SUBJECT: Novak Sanitary Landfill

MEMORANDUM

SUBJECT: Novak Landfill Superfund Site ([REDACTED])

Re: de maximis letter, February 12, 1993
Novak Sanitary Landfill NPL Site
South Whitehall Township
Lehigh County

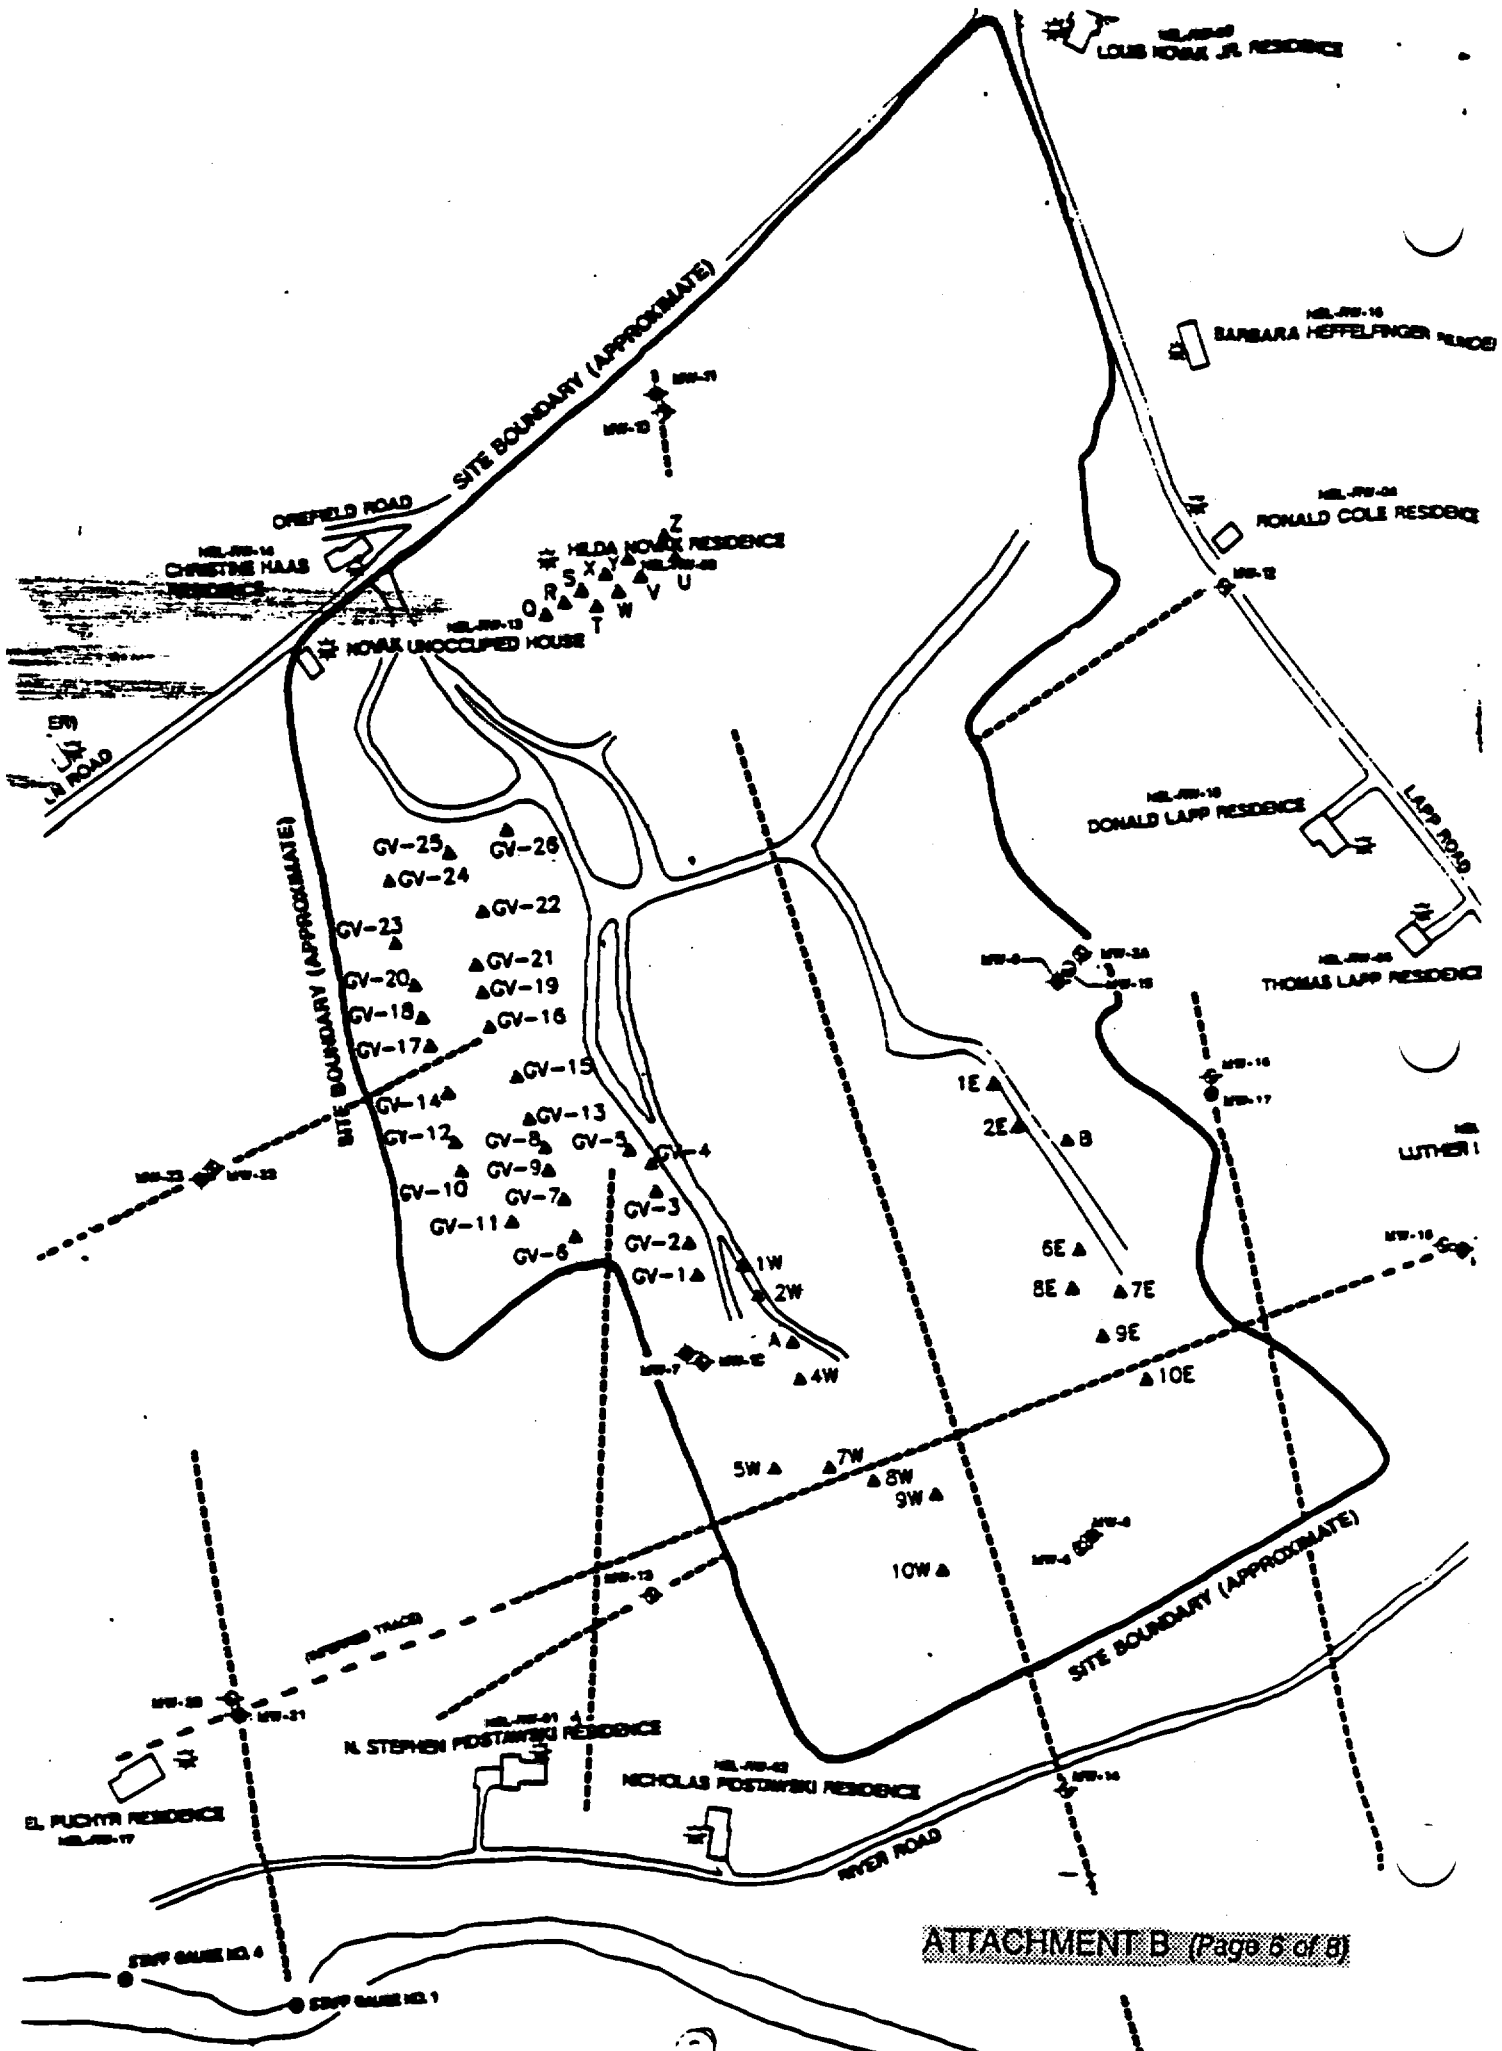
EVEN ABOUT
11 FT. ORS,
THERE ARE
LEACHATE
MOUNDING

Table A-1 (continued). Soil Gas Survey Results, Novak Sanitary Landfill

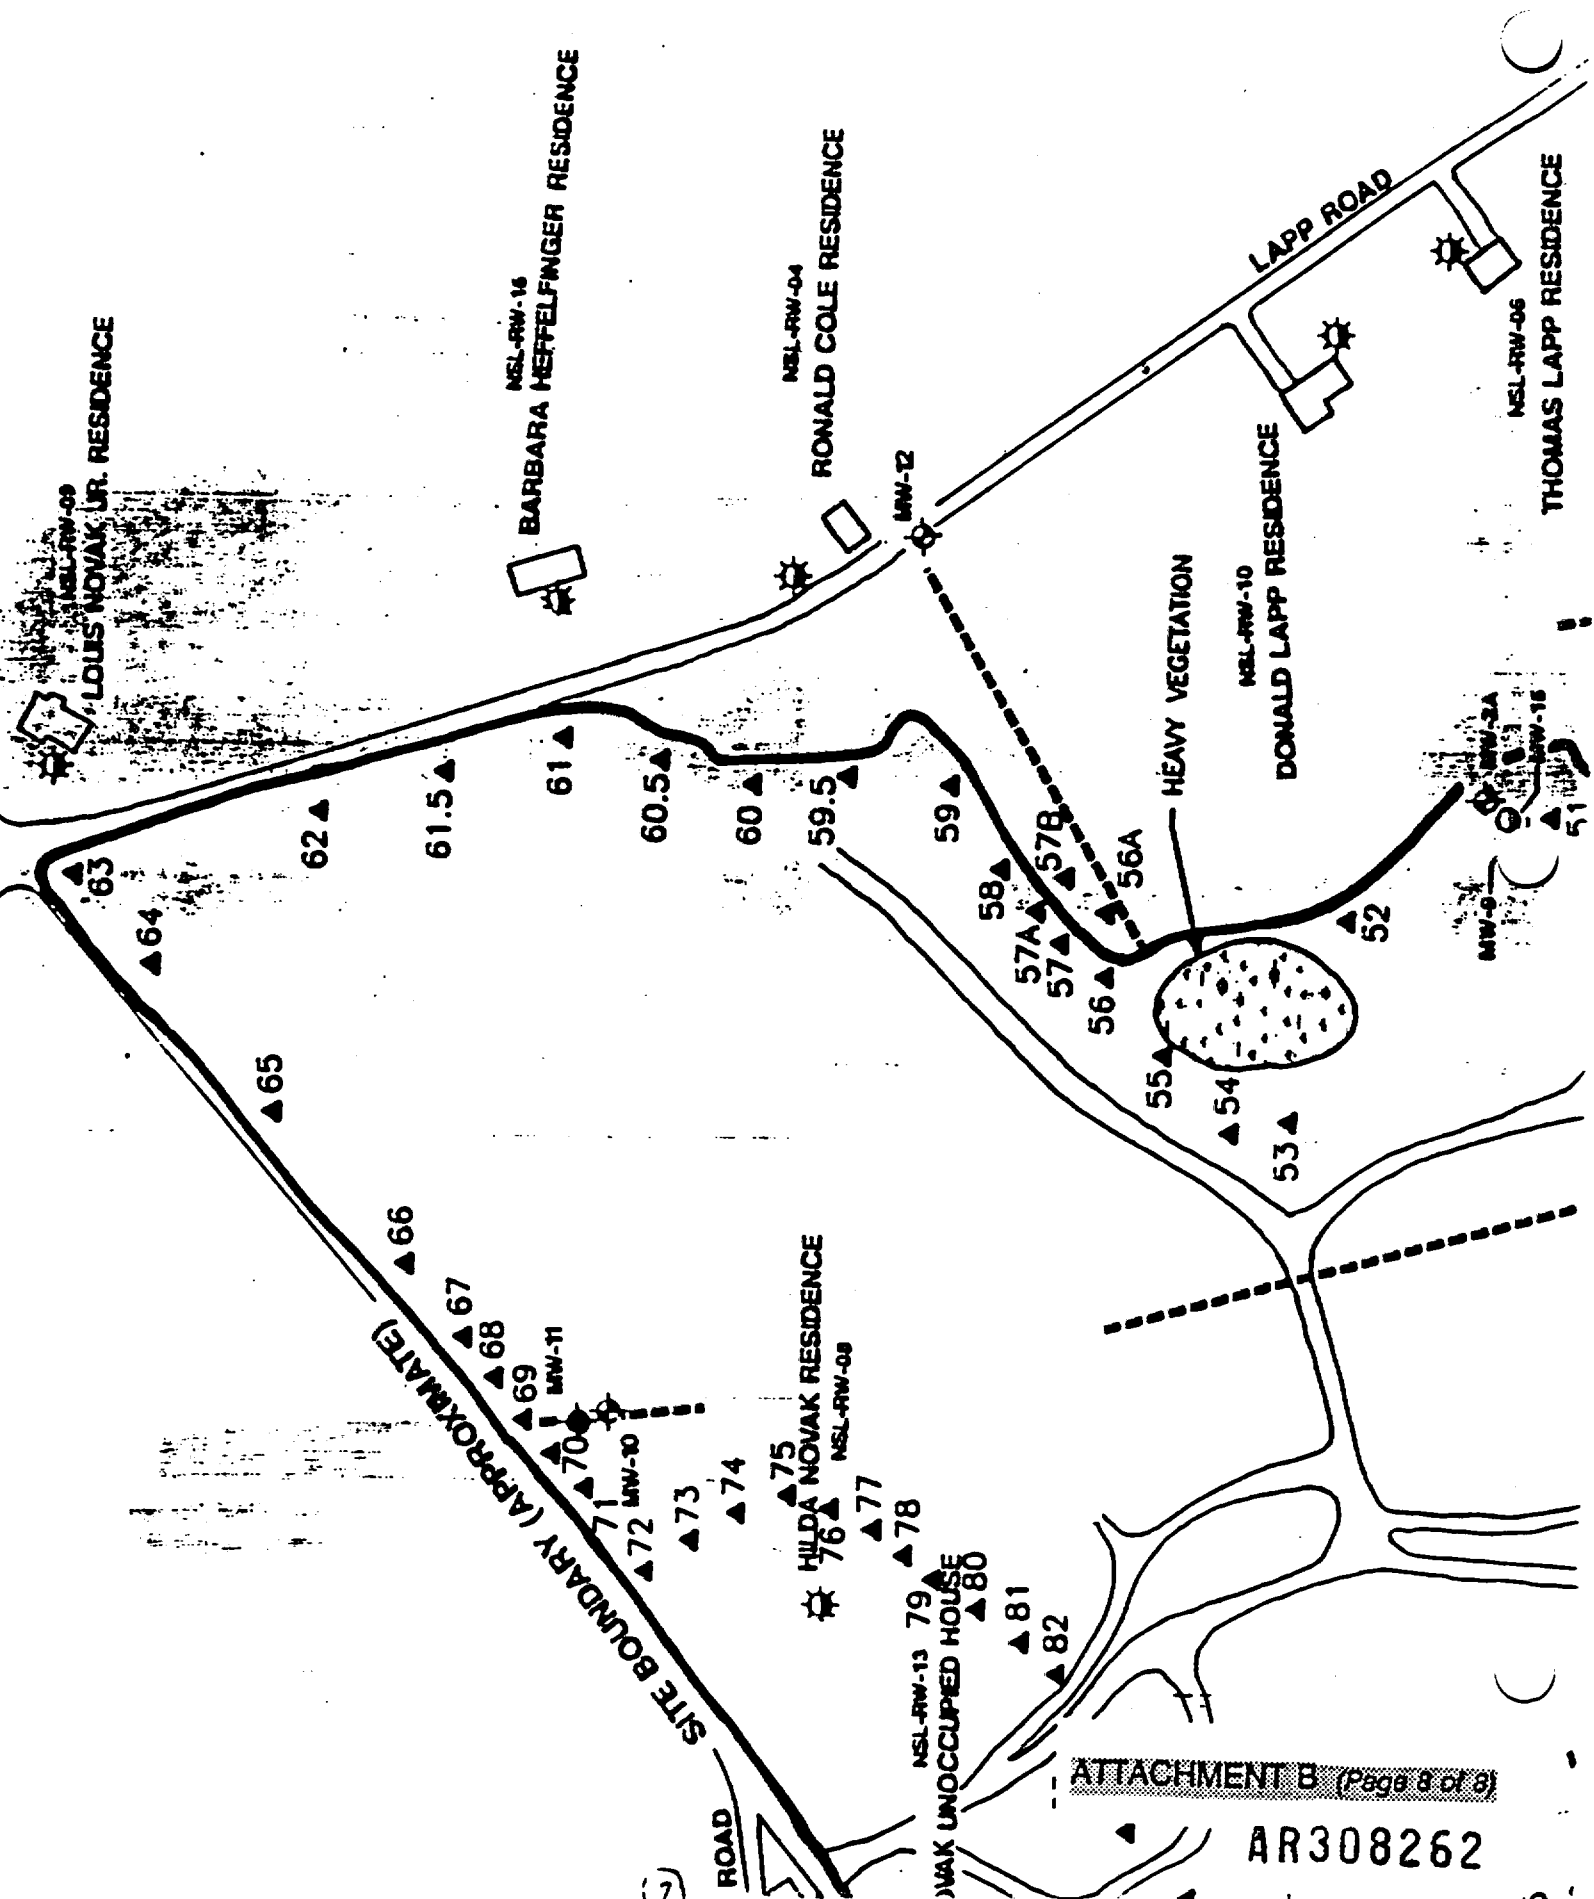
MEANS
SOME
VOC
EXISTED
